Service Bulletin

Bulletin No.: 23-NA-220

Subject: Rattle or Vibration Noise Coming from Upper Dash - Windshield Area While Driving

Brand:	Model:	Model Year:		VIN:		Engine:	Transmission:
		from	to	from	to		
Cadillac	XT4	2024	2024	-	-	All	All

6488112

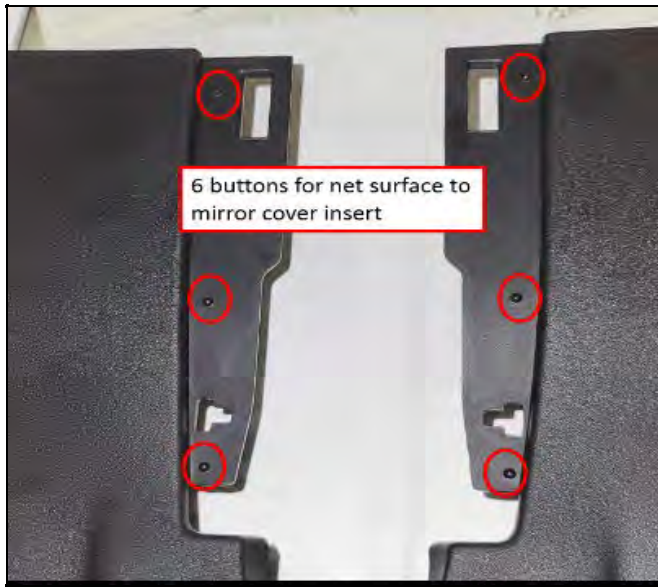
Dealers are to remove the insert from the cover. (see below).

6488114

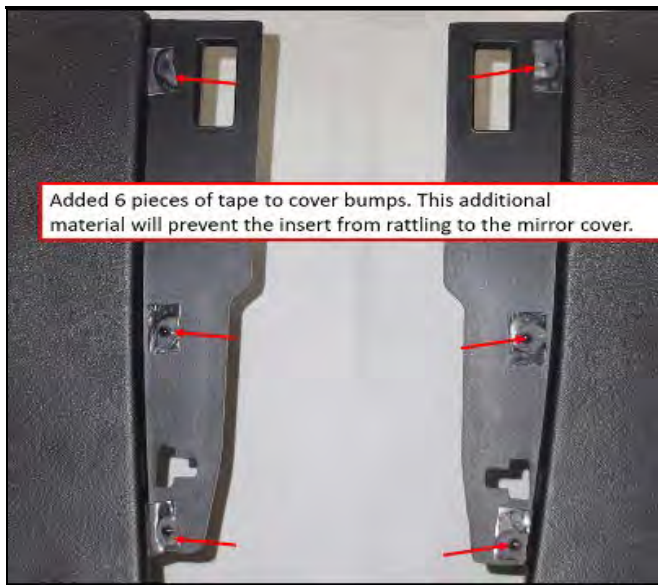
Locate the 6 raised buttons. (see below)

Using flocking or felt tape, the technician should cut 6 pieces and cover the buttons. (see below)
